Item Name: Crosstube Turning Detail

DART AEROSPACE LTD	Work Order:	94001
Description: Crosstube Assembly (412 High Aft)	Part Number:	D412-664-243
Inspection Dwg: D412-664-243 Rev: E		Page 1 of 2

DRAWING NO. D412-664-243	TITLE CROSSTUBE ASSEMBLY (412 HI AFT)	REV. E	DART AEROSPACE LTD ENGINEERING ORDER		D.E.O. NO. D412-664-243-E-1	SHEET NO. SHEET 1 OF 2	SCALE NTS
DRAWN	CHECKED	MFG. APPR.	APPROVED	DE APPR.			
DATE 11.03.31	DATE 11/03/31	DATE 11.03.31	DATE 11/03/31	DATE 11.03.31

DRAWING NO. D412-664-243	TITLE CROSSTUBE ASS'Y (412 HI AFT)	REV. E	DART AEROSPACE LTD ENGINEERING ORDER		D.E.O. NO. D412-664-243-E-2	SHEET NO. SHEET 1 OF 1	SCALE NTS
DRAWN 9P	CHECKED ASS	MFG. APPR. E	APPROVED MP		DE APPR. H		
DATE 11.09.07	DATE 11.09.19	DATE 11.09.19	DATE 11.09.19		DATE 11.09.19

**D412-664-243
ASSEMBLY DETAIL**

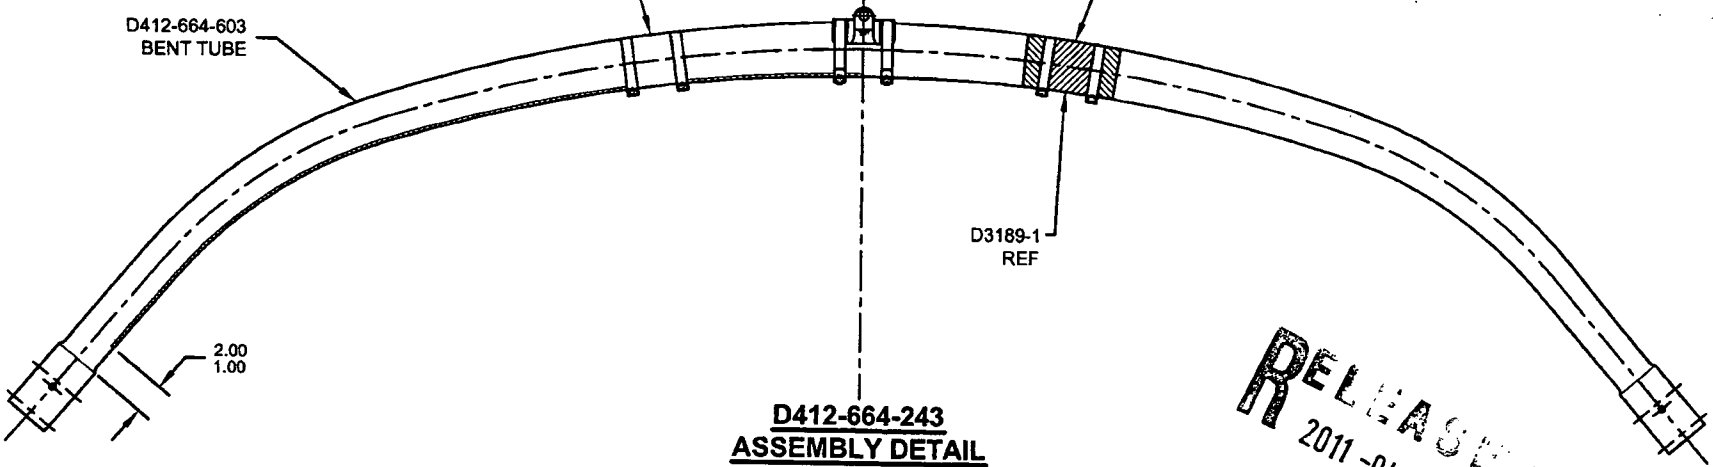
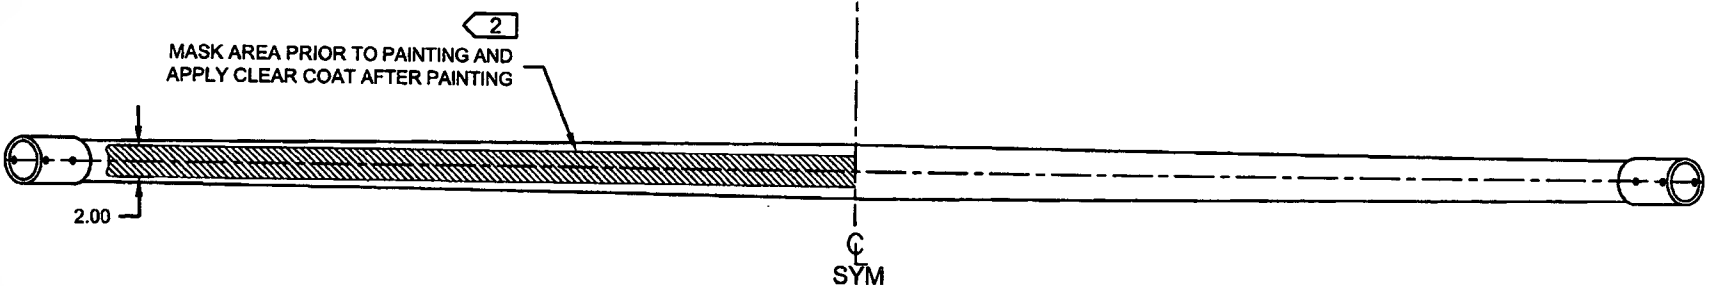
REMOVED ABRASION STRIP IN FAVOR OF A THIN LAYER OF PROSEAL 890.

IS:

16 14
 D3189-1 CHAFING SHIELD (1, INSTALLED OVER PROSEAL 890)
 MS21920-28 CLAMP, 2X
 2 PL
 D412-664-603
 BENT TUBE

WAS:

14 16
 D2856-600-1009 ABRASION STRIP
 D3189-1 CHAFING SHIELD (1, INSTALLED OVER ABRASION STRIP)
 MS21920-28 CLAMP, 2X
 2 PL

**D412-664-243
ASSEMBLY DETAIL**

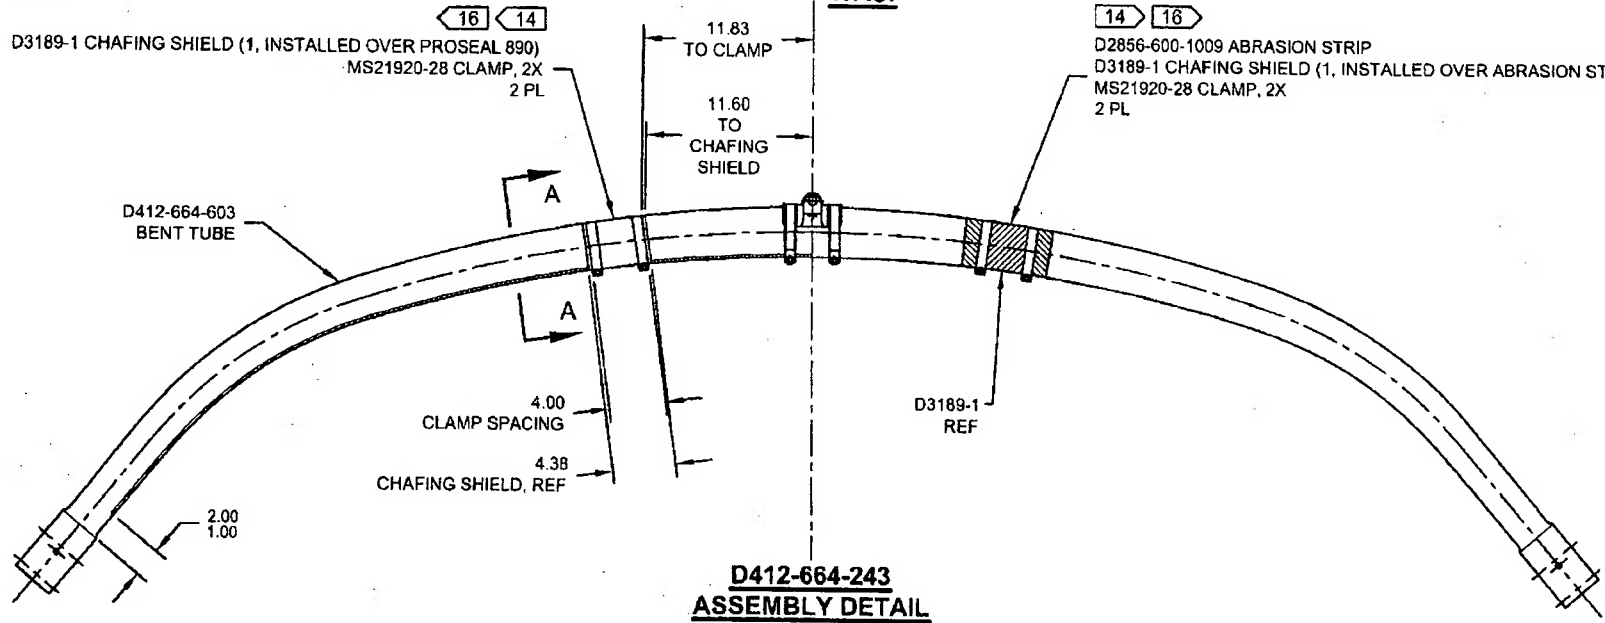
REMOVED ABRASION STRIP IN FAVOR OF A THIN LAYER OF PROSEAL 890. UPDATE INSTALLATION OF CHAFING SHIELDS AND REDUCE TORQUE TO 40-50 IN-LBS. THIS ENGINEERING ORDER SUPERCEDES DEO D412-664-243-E-1.

IS:

D3189-1 CHAFING SHIELD (1, INSTALLED OVER PROSEAL 890)
MS21920-28 CLAMP, 2X
2 PL

WAS:

D2856-600-1009 ABRASION STRIP
D3189-1 CHAFING SHIELD (1, INSTALLED OVER ABRASION STRIP)
MS21920-28 CLAMP, 2X
2 PL
